Re: Possible Deffective Curtain Type Fire
Dampers as furnished to Zack Company by
American Warming and Ventilating Inc.

Subject: Reportable 10 CFR Part 21

Ref: Zack P.O. No. 9505
Commonwealth Edison/LaSalle Nuclear Station
AWV Job No. 90116

Subject: Curtain Type Fire Damper Discrepancies

SKETCH "A"

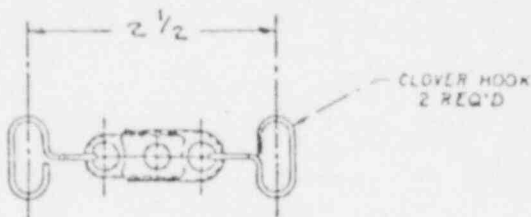
There is a possibility that certain Curtain Type Fire Dampers shipped before March 24, 1981 may not close when the fusible link separates.

These fire dampers are units 18" wide and narrower which have small fusible links. A list of the applicable tag numbers is attached.

1. Two types of fusible link assemblies are used as shown in sketches "A" and "B".
2. Inspect and measure the fuse link assemblies and identify the part as an "A" (2 1/2") or "B" (3").
3. If the part is identified as an "A" assembly (2 1/2"), remove the fuse link assembly as follows:
 - a. Support the blade stack so as to remove the loading from the fuse link assembly.
 - b. Remove the fuse link assembly by straightening the clinch straps and sliding the assembly from them.
 - c. Replace the fuse link assembly with a "B" assembly by sliding the clinch straps through the wire loops.
 - d. Bend the clinch straps upward and firmly secure the new fuse link assembly against the bottom of the blade stack.
 - e. Remove any supports and inspect to make certain that the fuse link assembly is centered on the blade stack. Shift the assembly until it is centered.

Attached is a set of instructions for inspection and, if dampers are found to be per sketch "A", instructions for replacement of clover hooks. If you find any dampers needing to have the clover changed, we will be happy to send you the necessary parts.
